Correction: A smart multi-pipette for hand-held operation of microfluidic devices

Correction for 'A smart multi-pipette for hand-held operation of microfluidic devices' by Byeongyeon Kim et al., Analyst, 2016, **141**, 5753–5758.

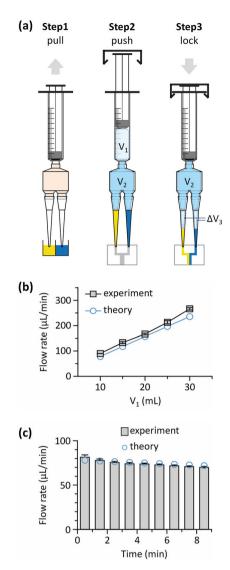
To reflect this change, amendments are required to Fig. 1 and the text.

- · Fig. 1b and c are affected by the correction needed to the theoretical estimation for the generated pressure by the smart pipette, and the overall corrected version of Fig. 1 is as follows:
 - The first sentence on p. 5755 should be amended as follows:
- 'If $V_2 \gg (\Delta V_3)_t$ and $V_1 \gg (\Delta V_3)_t$, the pressure change becomes negligible and thus the smart multi-pipette maintains a constant pressure during device operation.'
 - The fourth sentence of the third paragraph on p. 5755 should be amended as follows:
 - 'We note that the experimental value is higher than the theoretical expectation of 7.8%.'
 - The changes do not affect any of the conclusions of the article.
 - The Royal Society of Chemistry apologises for these errors and any consequent inconvenience to authors and readers.
